## DOVER PLANNING BOARD – AGENDA

Meeting Type: Regular Meeting  
Meeting Location: Council Chambers, City Hall, 288 Central Ave, Dover NH 03820  
Meeting Date: **Tuesday, October 8, 2019**  
Meeting Time: **7:00 pm**

Ms. Donna Benton  
Assistant City Planner  
City of Dover, Planning Department  
288 Central Avenue  
Dover, New Hampshire 03820

TITLE SHEET  
BELLAMY RIDGE II

**EX-1**

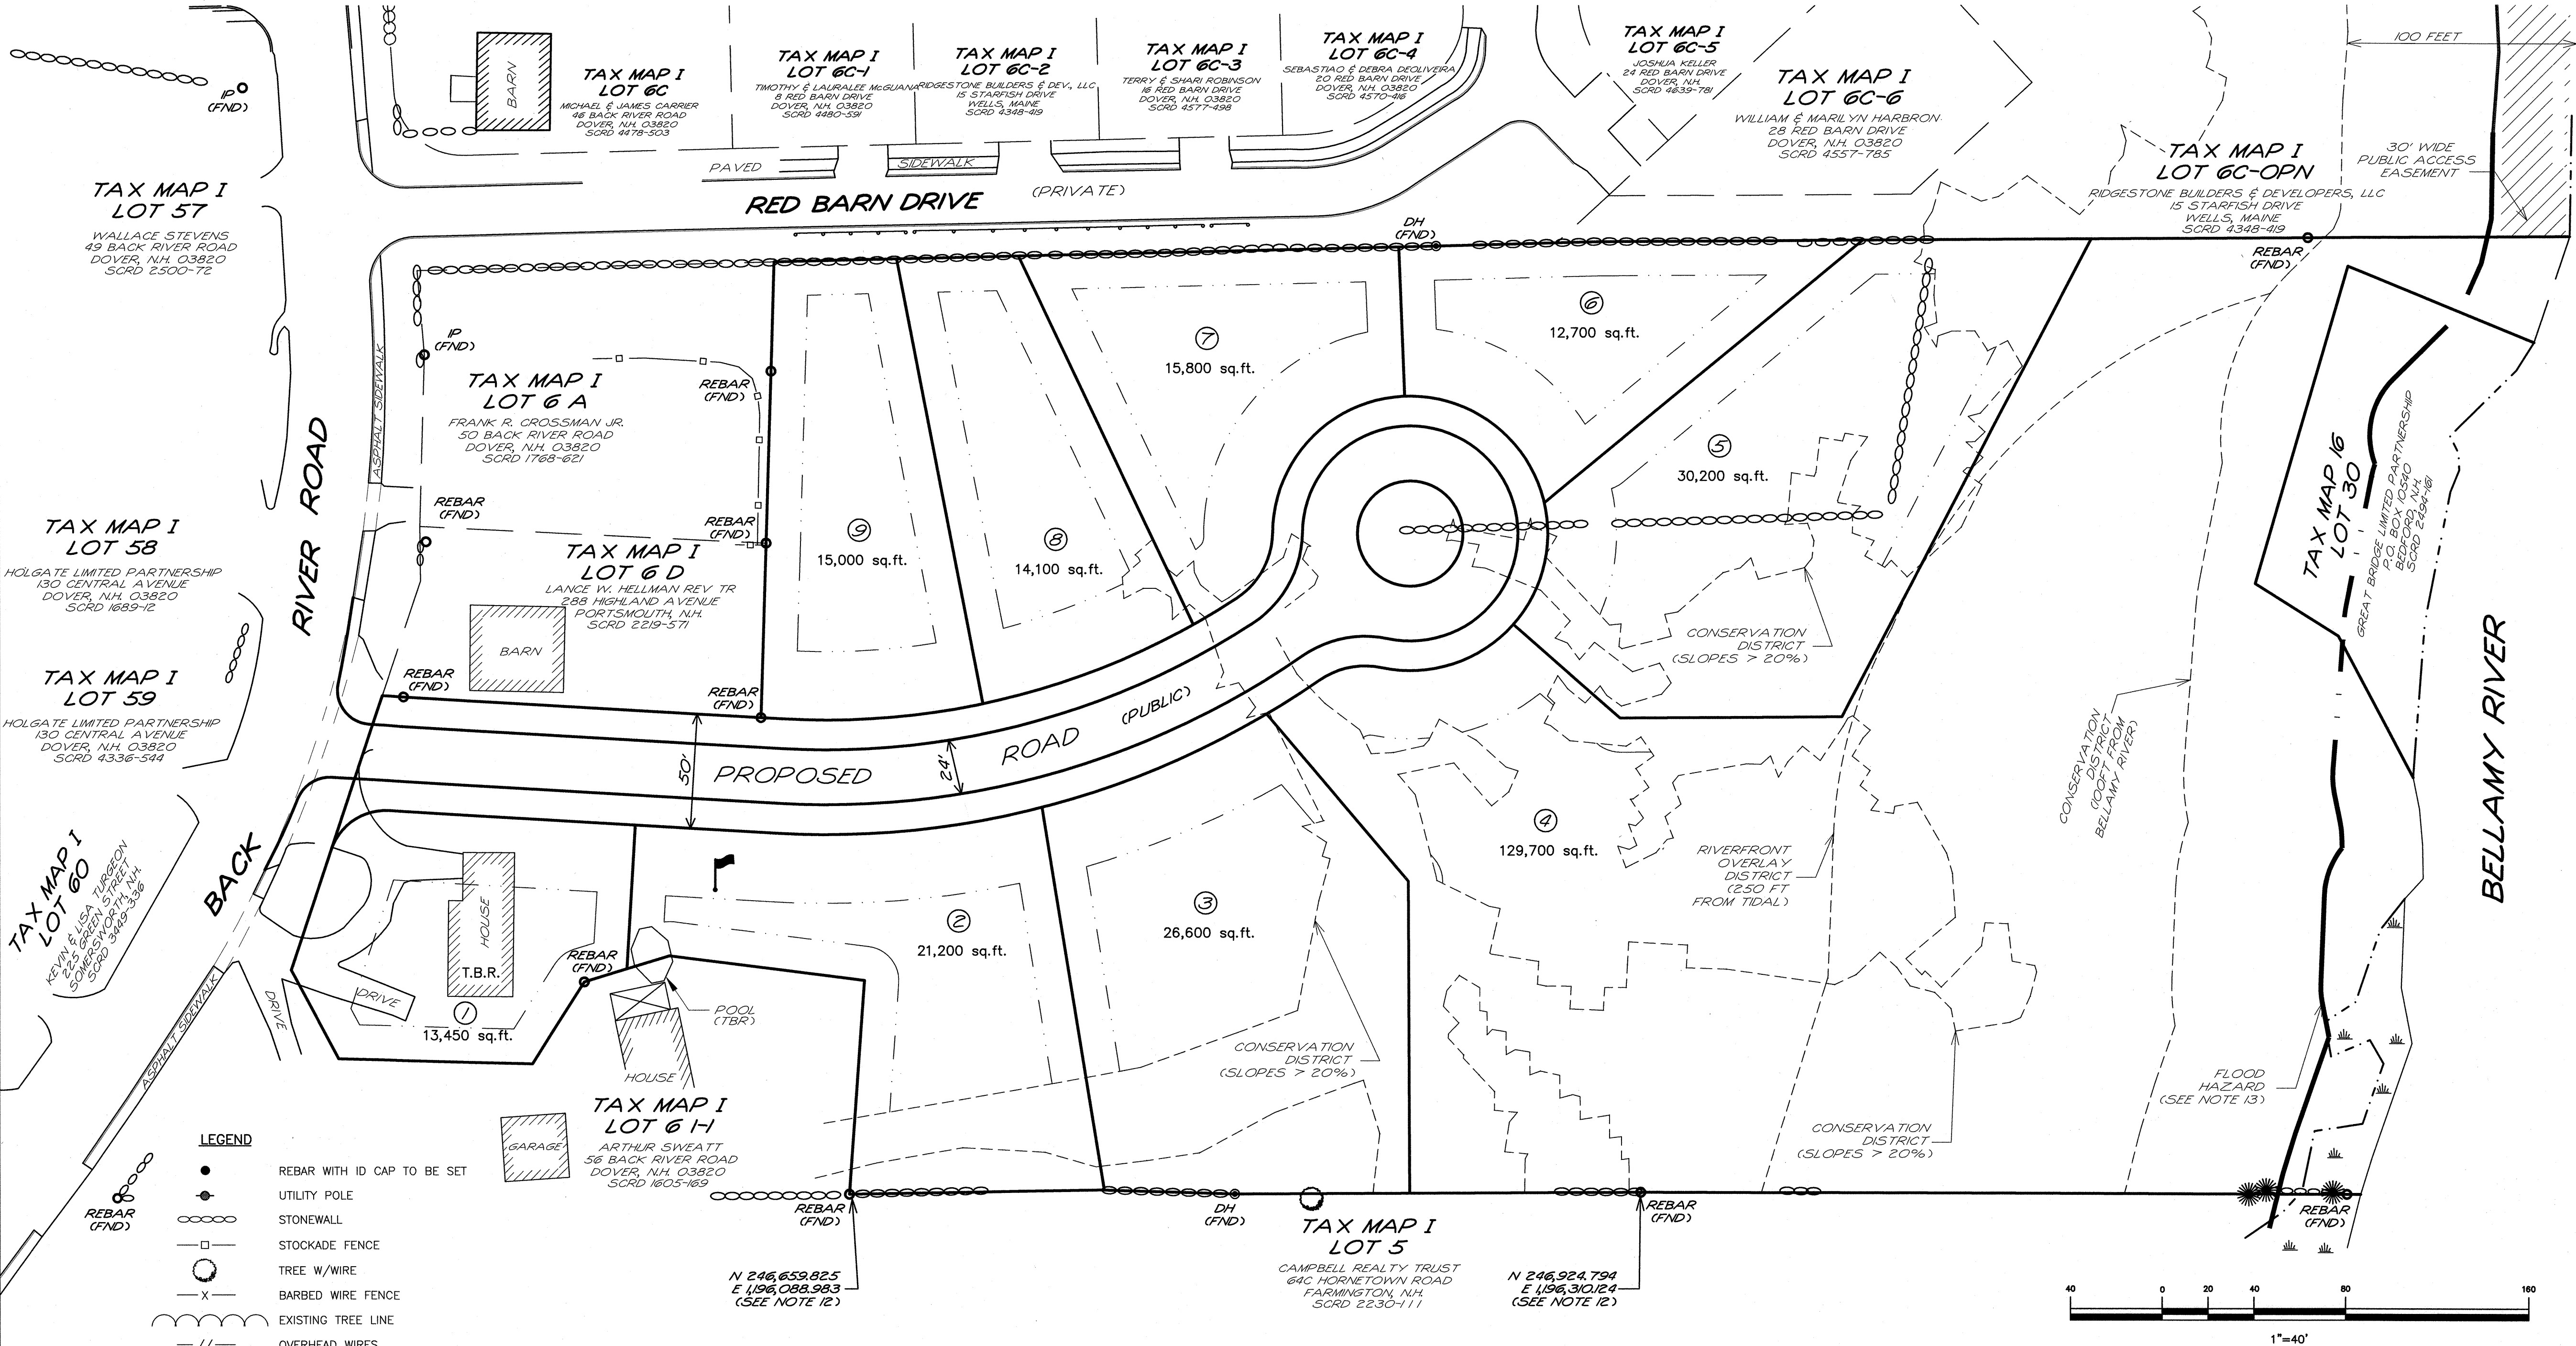
- o Widen Red Barn to 28' (parking on both sides)  
*Red Barn Drive has been widened to 28 feet.*
  - o Revise existing condition sheet to add garage on lot 6 1-1, sidewalk in front of lot 6-1 on Back River Road, telephone pole, and gas main  
*Sheet Ex-1 has been revised as requested.*

*Sheet Ex-1 has been revised.*

**SP-2**

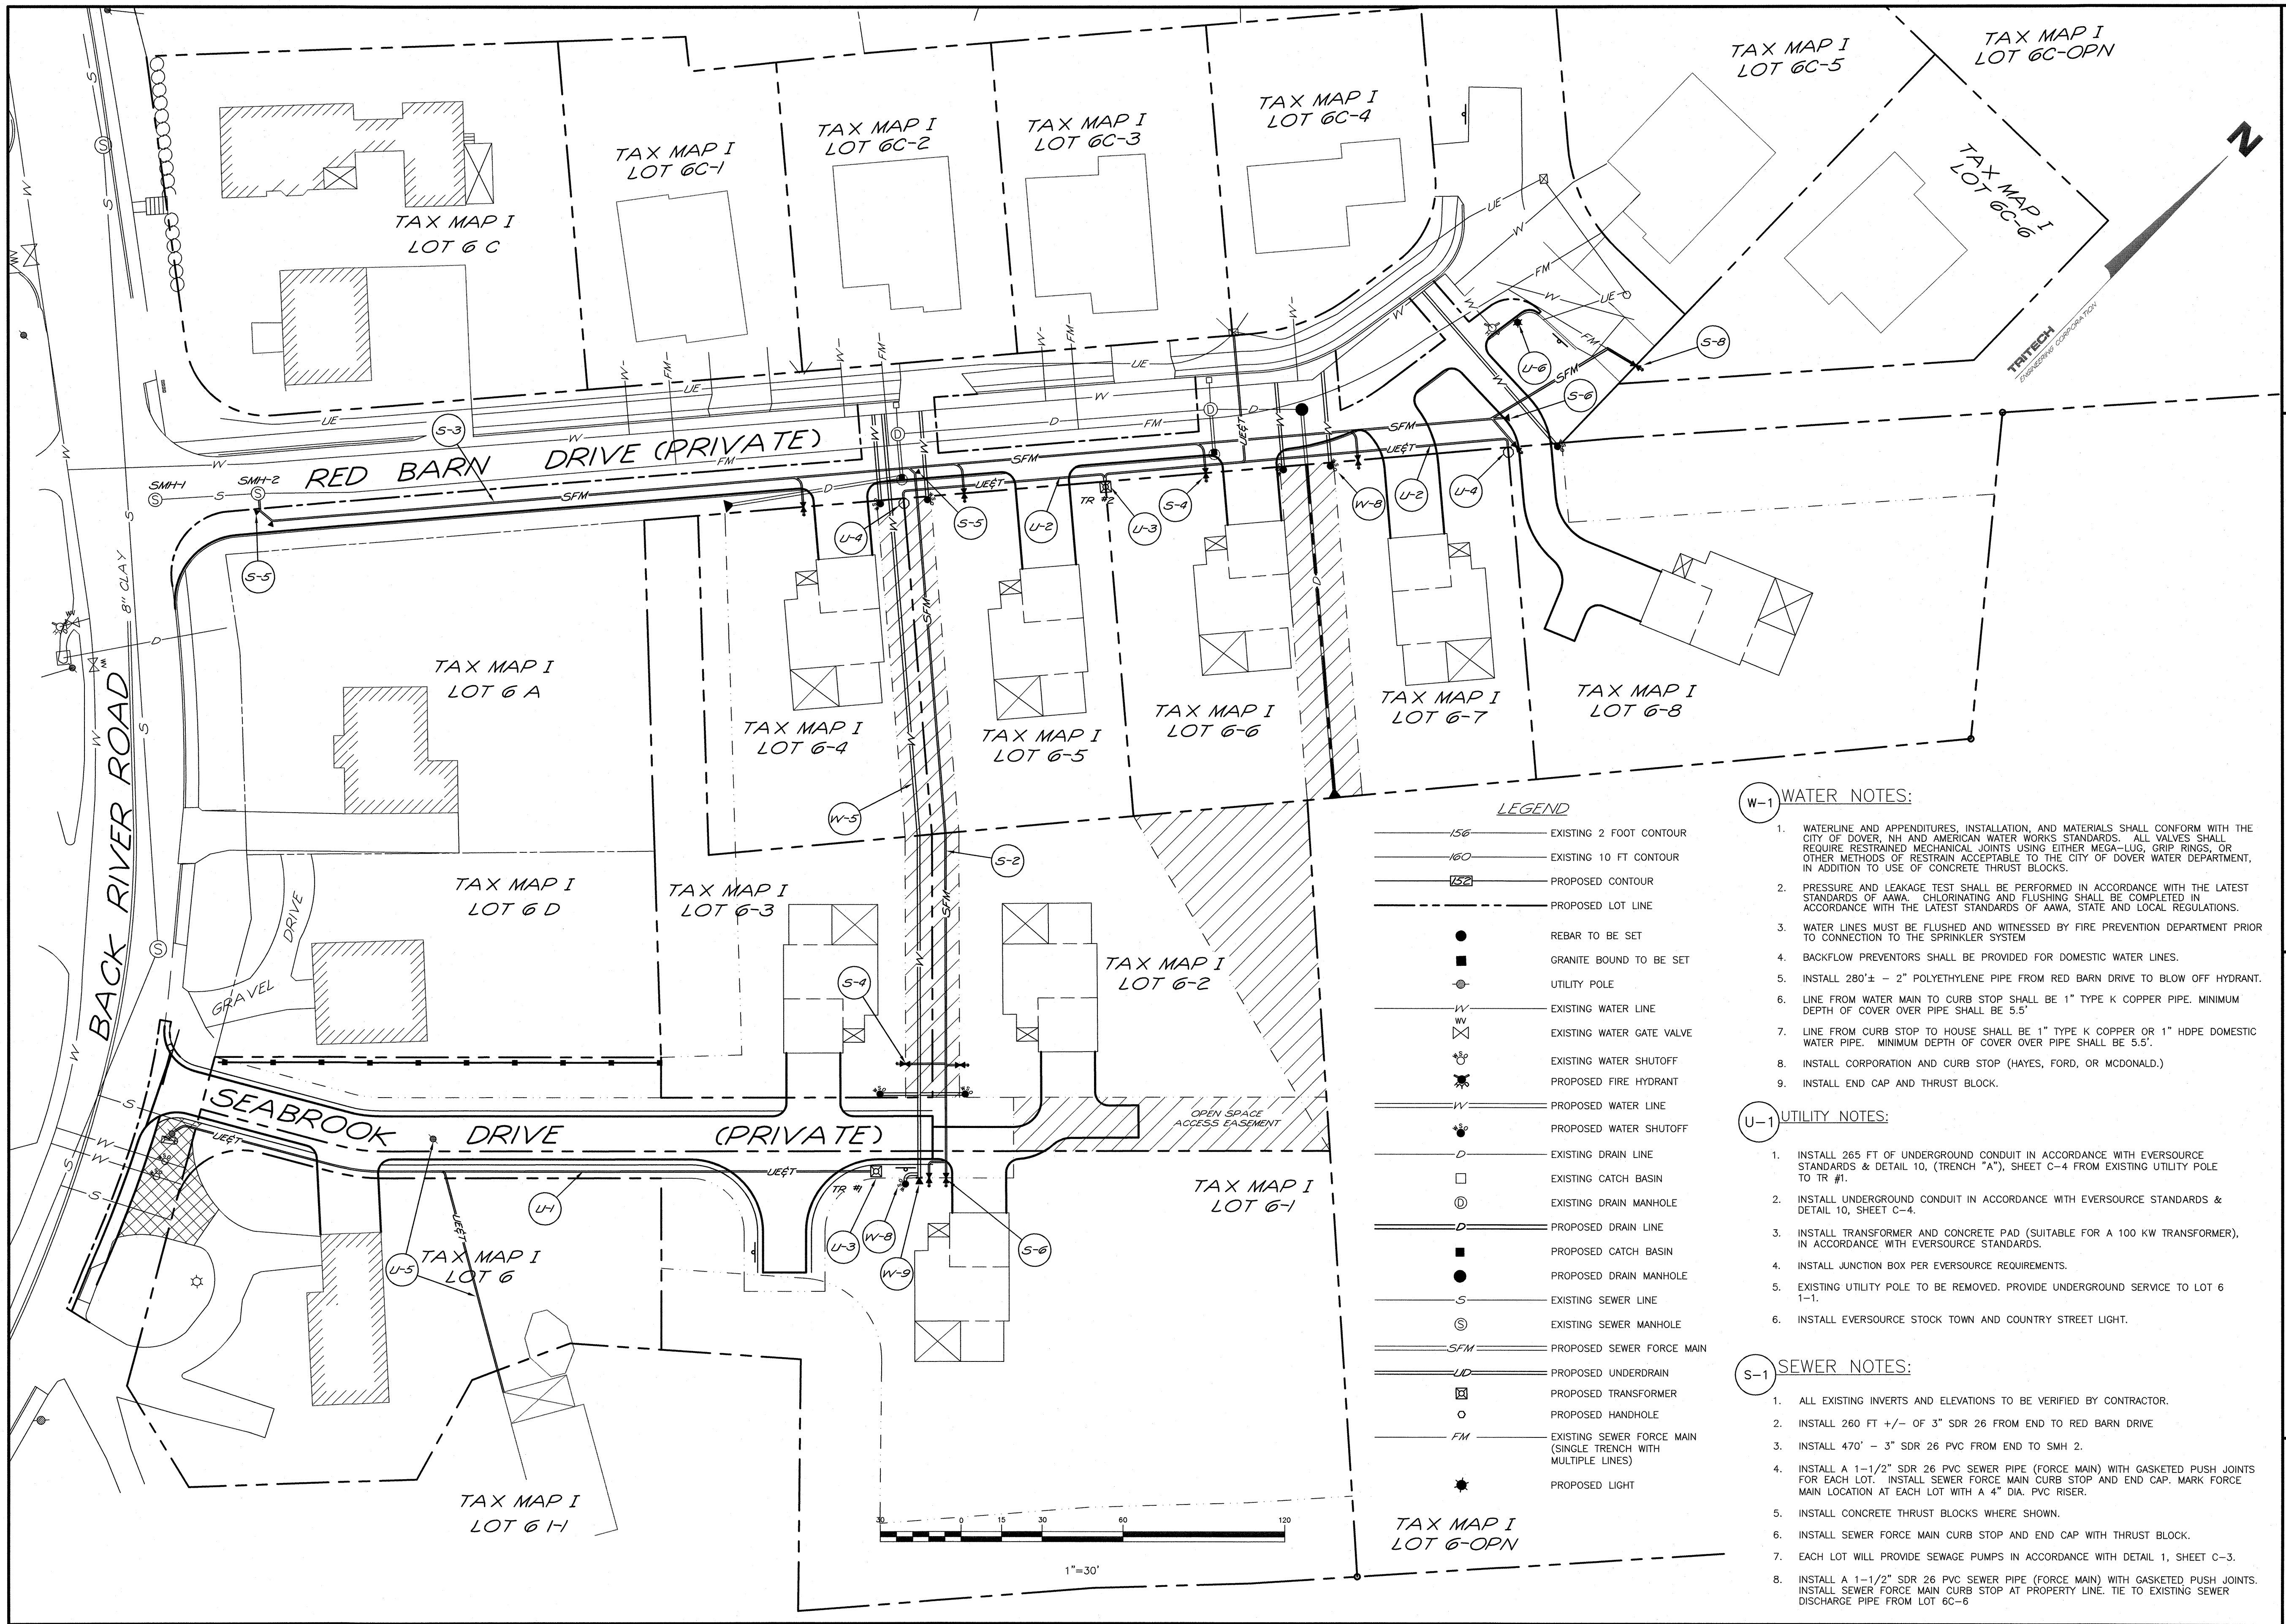
- Do not install the blow off hydrant  
*This has been removed from the plans.*
- Install stops on the sewer forcemain services  
*Sheet SP-2 has been revised accordingly.*
- Install stop at the end of the forcemain for the cleanout  
*Sheet SP-2 has been revised accordingly.*
- Lot 6C-6 is to connect to the common forcemain?  
*Sheet SP-2 has been revised accordingly.*
- Show path to open space on the plan. Can access to maintenance also act as access to common space.  
*An additional access easement has been added to the end of Seabrook Drive.*

② SLOPED GRANITE CURB SECTION  
NOT TO SCALE

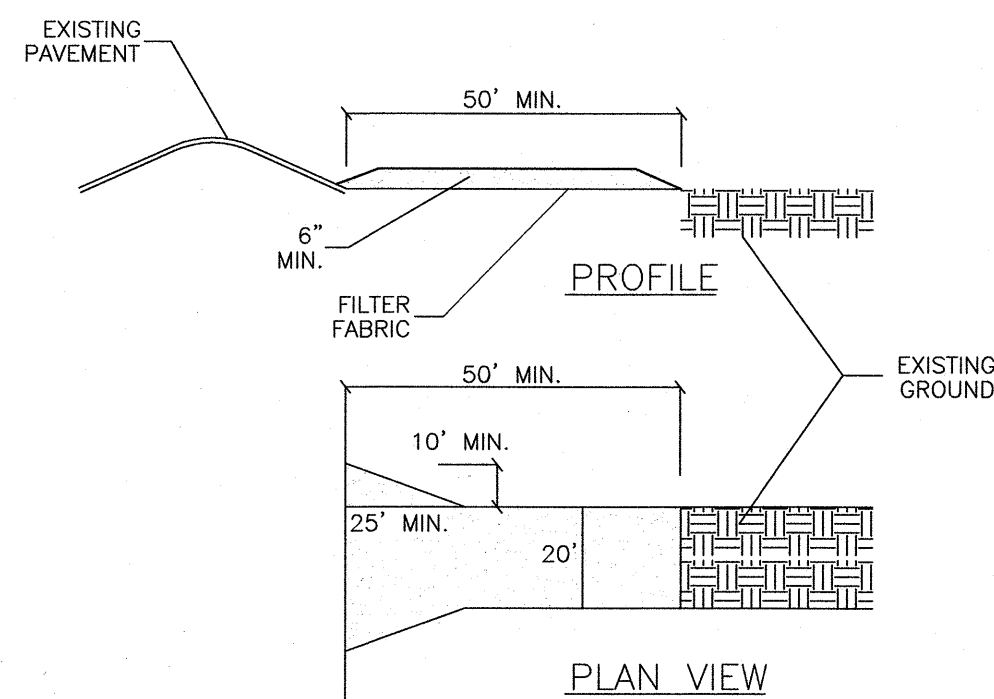
- Provide alternate street name (not Rogers Drive).  
*The name has been changed to "Seabrook Drive".*
- Sheet SP-1, note C-14 (regarding sloped granite curb) does not have corresponding label on the plan. Confirm that this the area adjacent to note C-15 as shown on plan.  
*The granite curb is shown on Red Barn Drive. The driveway removal and grading is on Back River Road.*
- Any interaction with property owner of Tax Map I, Lot 6-D about providing an access driveway? The plowing of proposed new roadway will almost certainly affect his/her access from Back River Road.  
*The driveway for 6-D remains intact. The existing drive for 54 Back River Road occupies the same location and we are not aware of any conflicts.*
